Work Session: City Hall Update

Eugene City Hall – Phase 1

Summary of Initial Cost Reduction Strategies for City Hall

2016-09-01
COST REDUCTION
STRATEGIES

BUILDING
ELEVATIONS - SOUTH

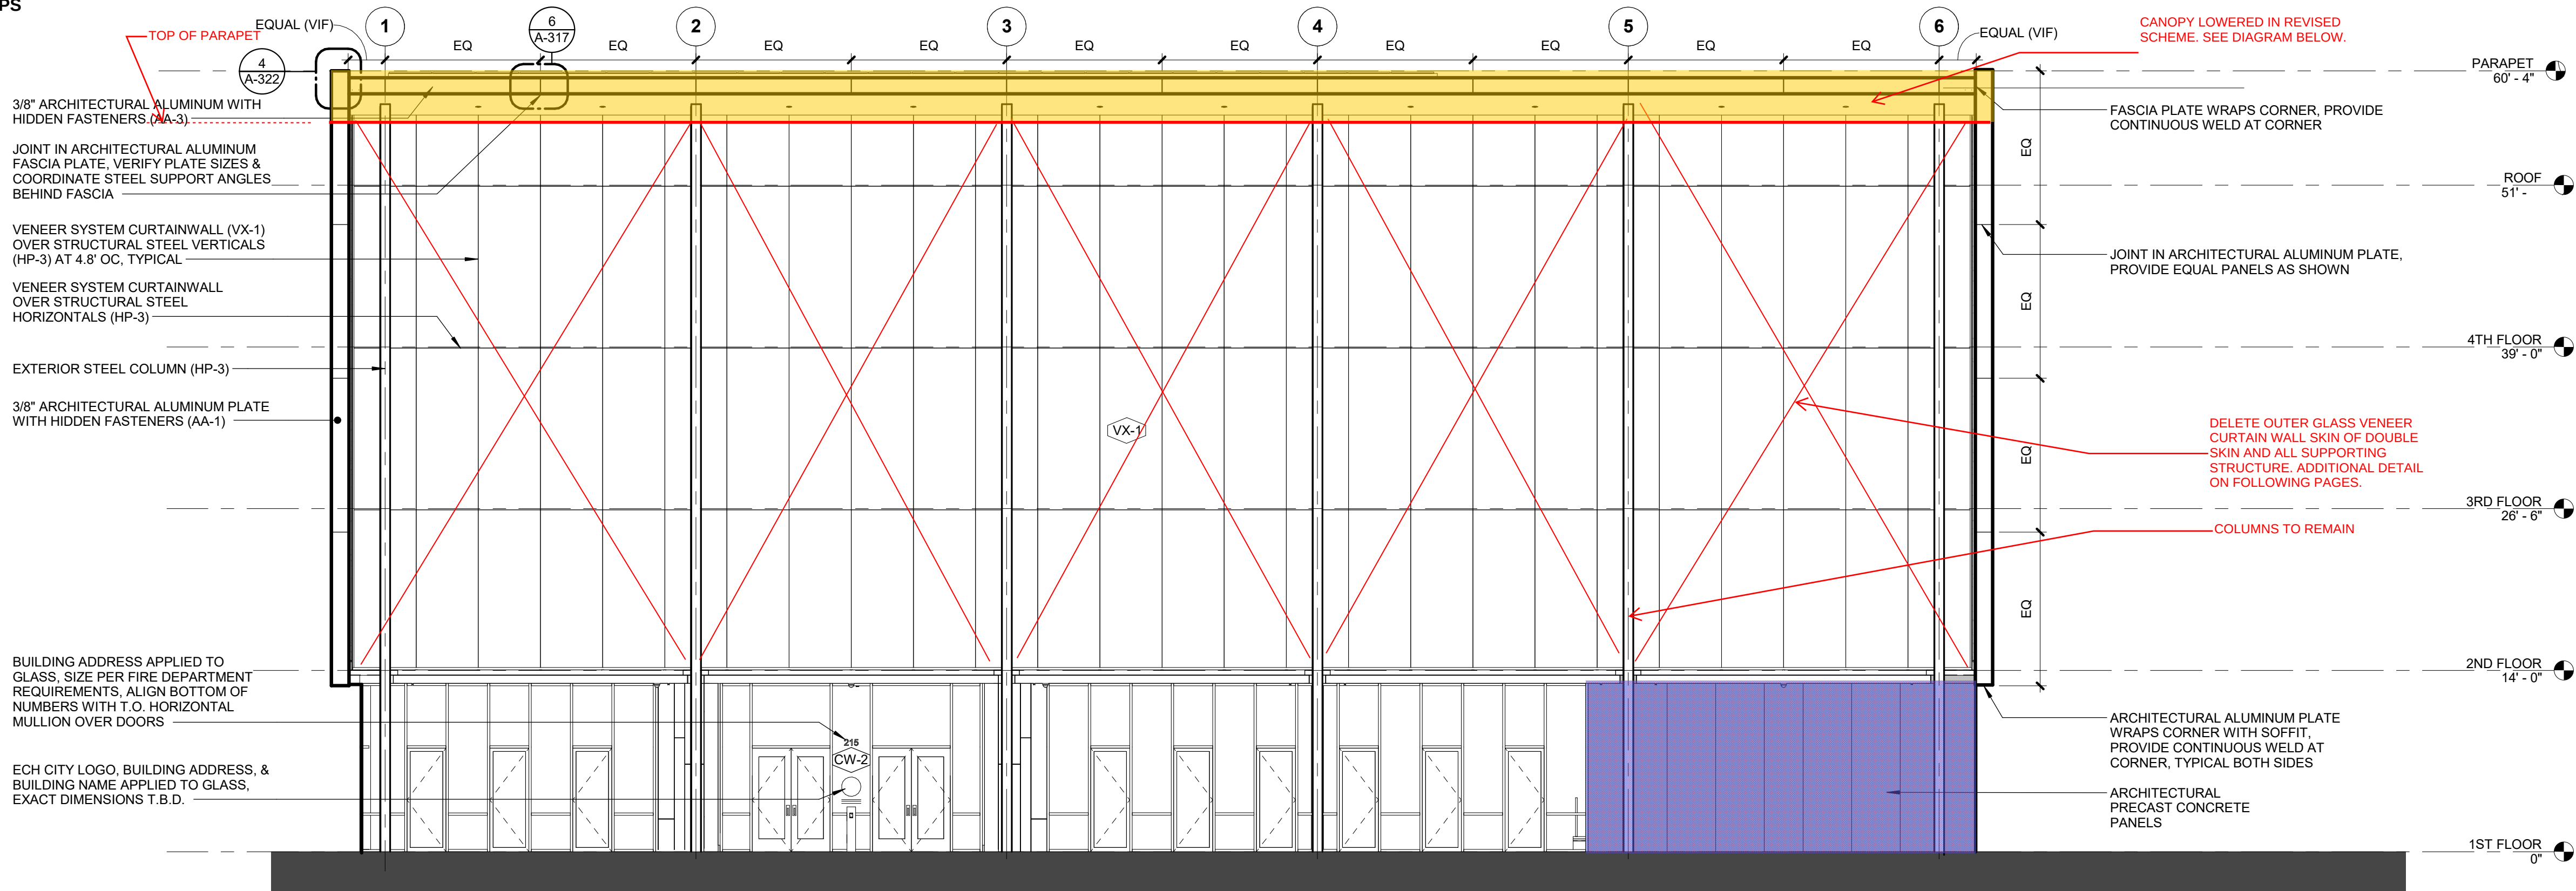
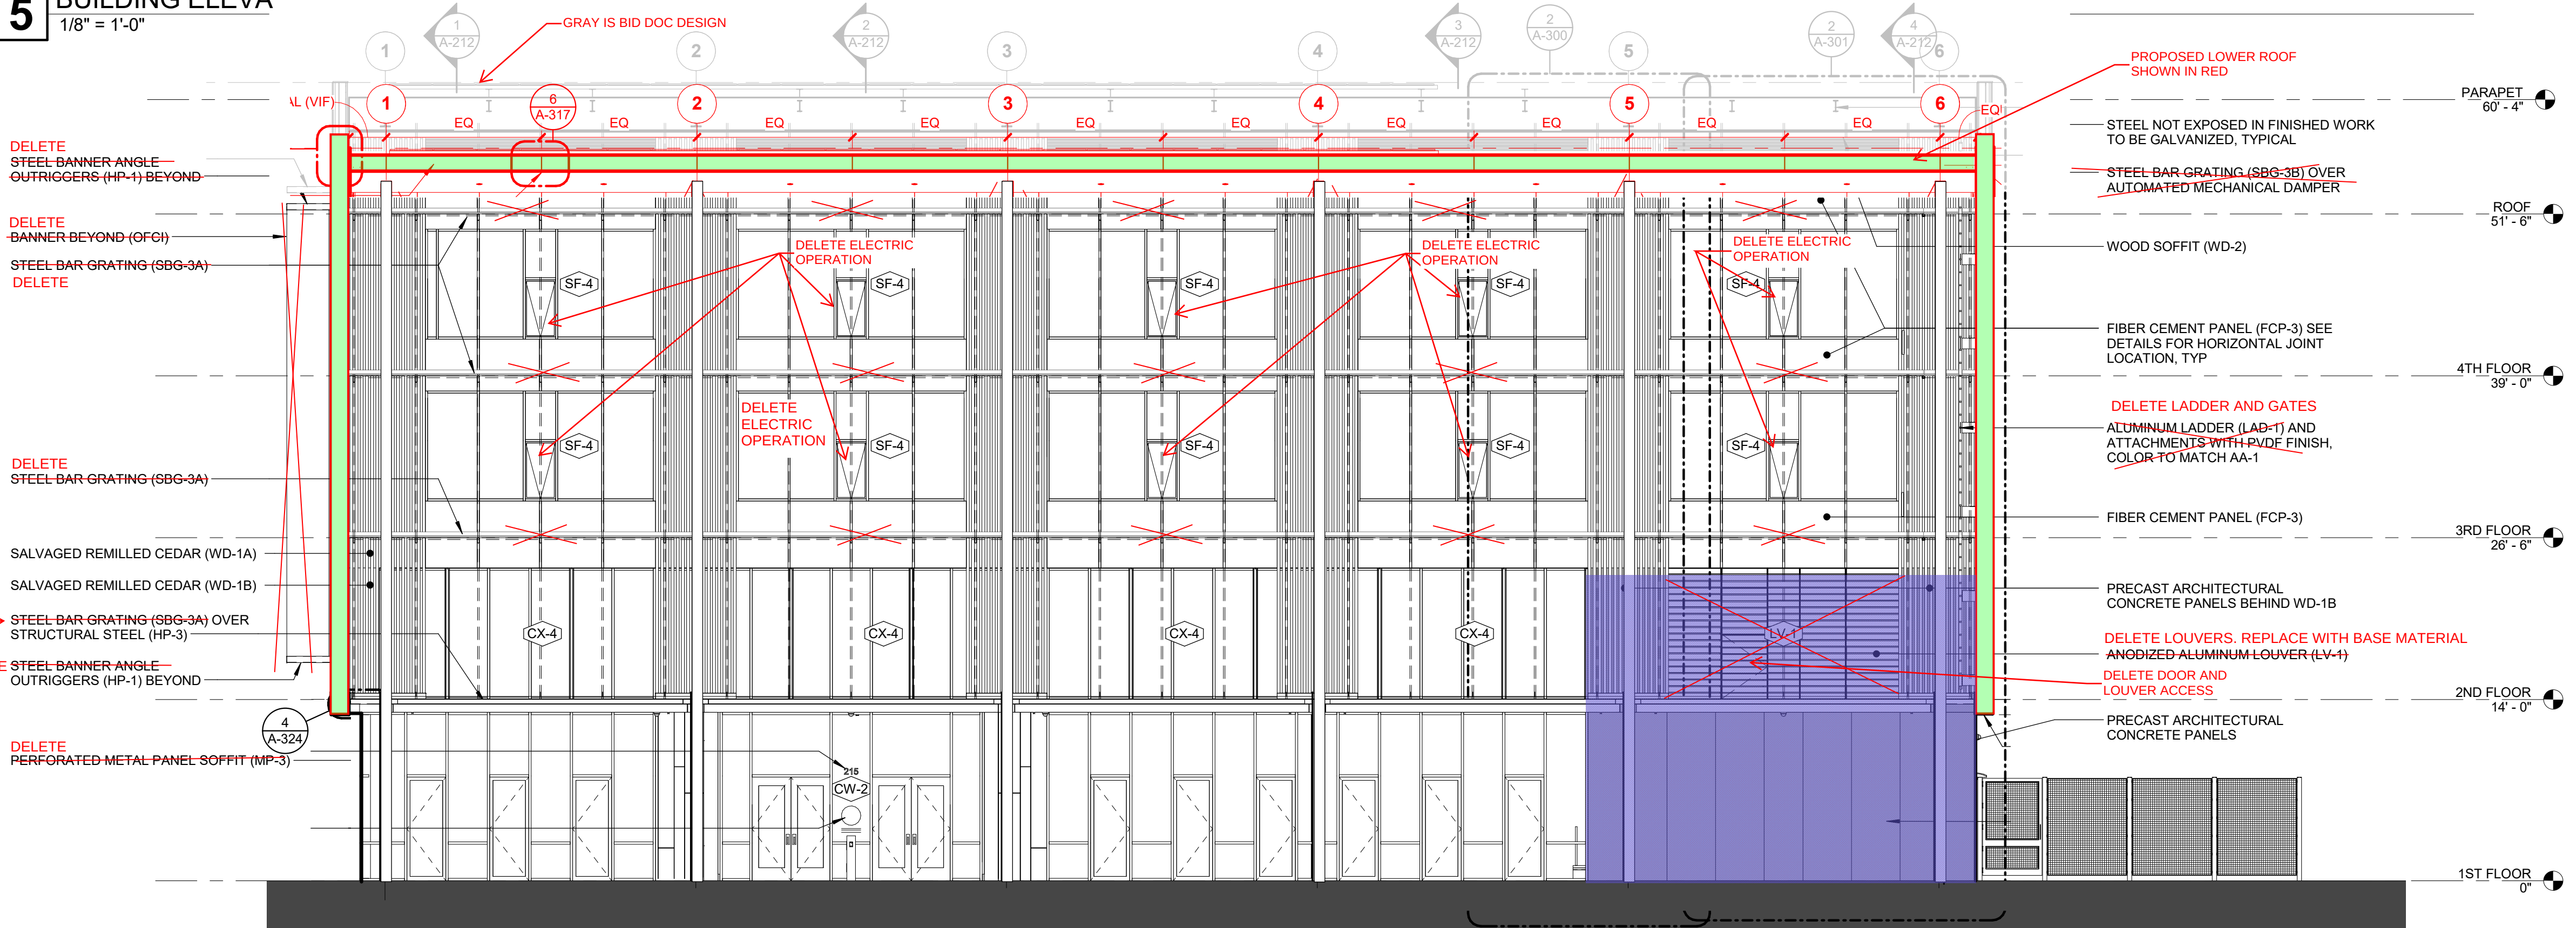
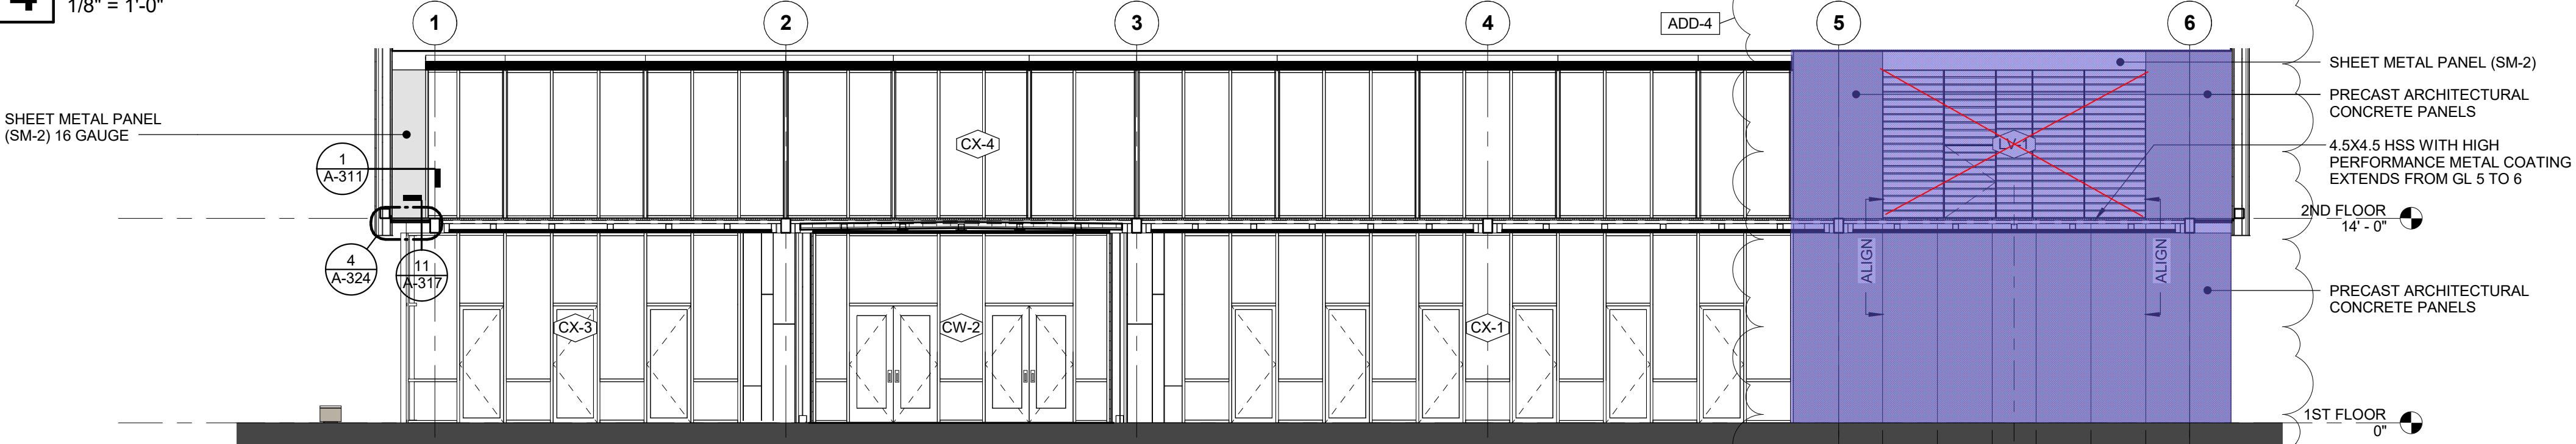
- CEMENT PANEL CLADDING**
FCP-1, FCP-2, FCP-3:
1. SUBSTITUTE CEMBRIT PANEL.
2. ELIMINATE SECONDARY BACK UP CHANNEL AND ATTACH DIRECTLY TO KNIGHT WALL SYSTEM.
- DELETED WALL SURFACE**
- 3/8" ALUMINUM TRIM REVISION**
OPTIONS:
1. 3/8" GALVANIZED OR POWDER COATED STEEL, SIMILAR ATTACHMENT TO DETAILED ALUMINUM.
2. HEAVY GAGE SHEETMETAL
3. EQUITONE EXPOSED FASTENER CLADDING.
- MP-1 REVISION OPTIONS:**
1. GAGE METAL CLADDING - NORTH CLAD AL SERIES OR SIMILAR.
2. EQUITONE EXPOSED FASTENER CLADDING.
- BASE MATERIAL OPTIONS:**
1. PRECAST WITH 12" FORM LINER.
2. PRECAST WITH SMOOTH ACID WASH.
3. BRICK - WALL FRAMING, WEATHER BARRIER AND INSULATION TO MATCH TYPICAL AT UPPER FLOORS.
4. PORTLAND CEMENT STUCCO RAIN SCREEN, WALL FRAMING, WEATHER BARRIER AND INSULATION TO MATCH TYPICAL AT UPPER FLOORS.
